Project HEATH HOUSE, HAMPSTEAD, NW3 7ET		
Drawing PROPOSED EAST ELEVATION		
Drawing No. HH-1017/AP 04E	Scale 1:50 @ A1 / 1:100 @ A3	Date 11.05.2017

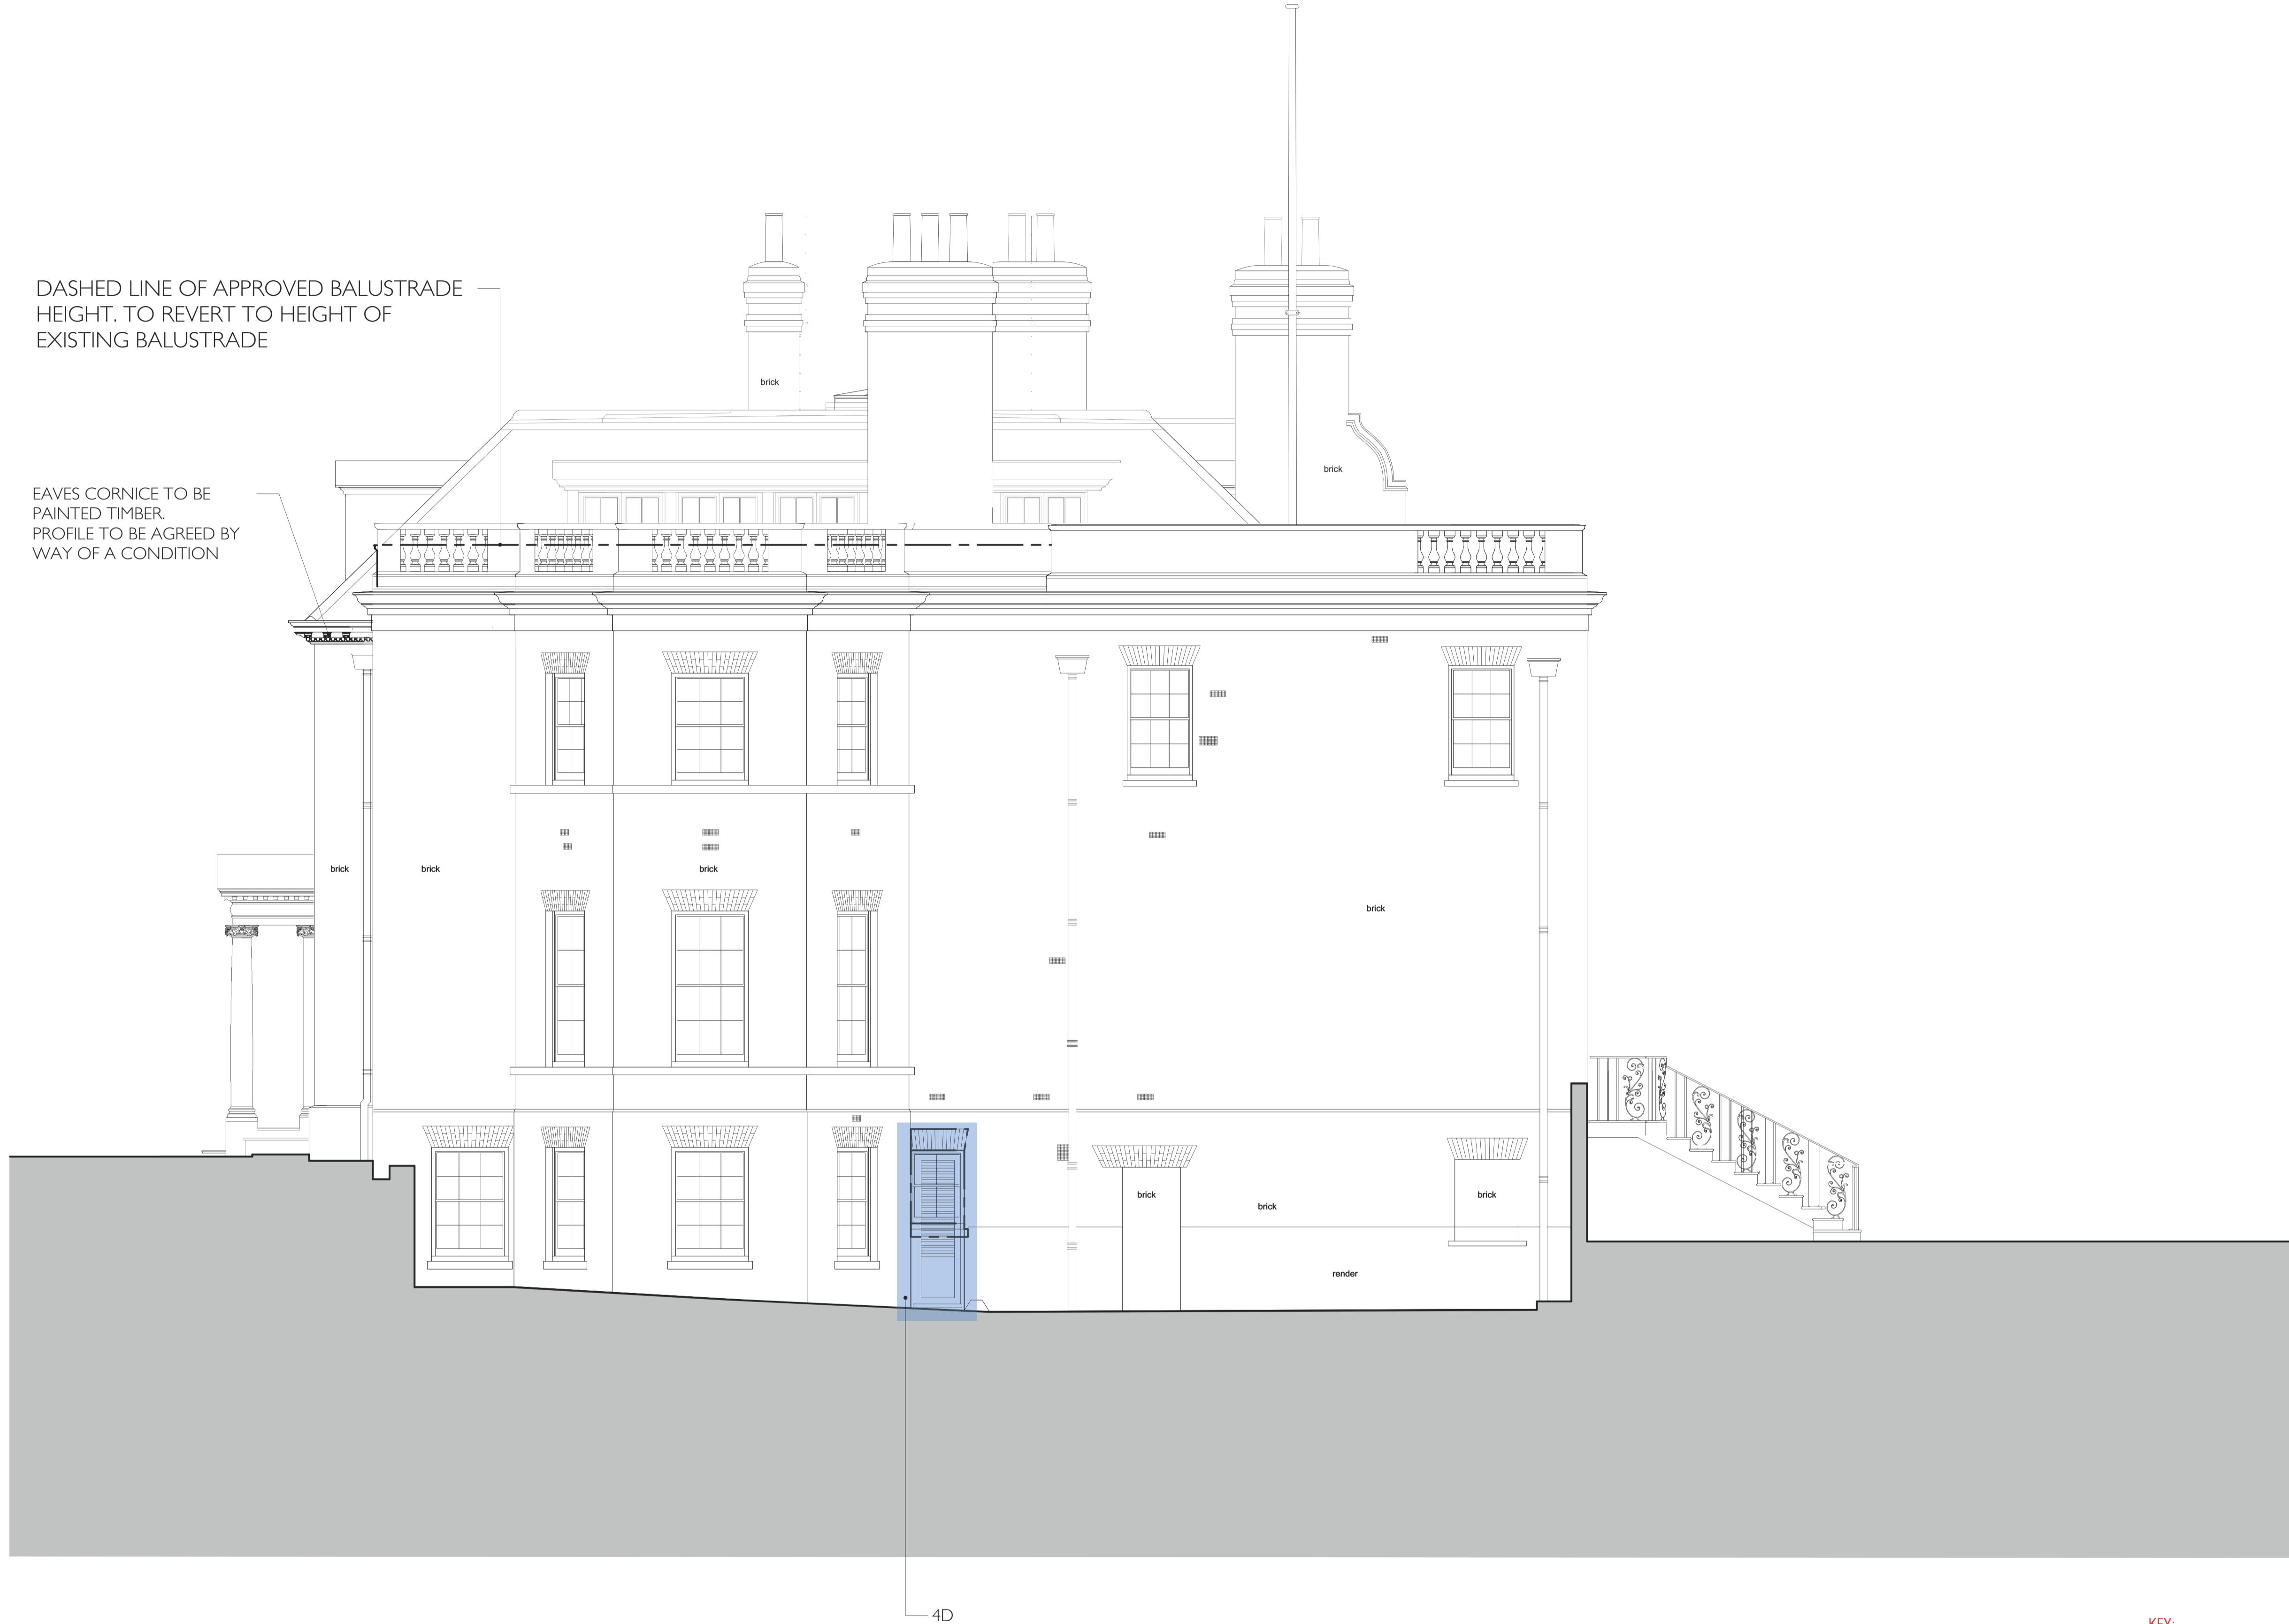
DASHED LINE OF APPROVED BALUSTRADE HEIGHT. TO REVERT TO HEIGHT OF EXISTING BALUSTRADE

EAVES CORNICE TO BE PAINTED TIMBER. PROFILE TO BE AGREED BY WAY OF A CONDITION

Rev C: 14/07/17 Existing lower ground window converted to door to provide external access to pool plant
 Rev D: 26/06/18 Amendments following meeting with Conservation Officer. Also refer to submitted, revised, Design & Energy Statement
 Rev E: 02/07/18 Note added re: eaves cornice
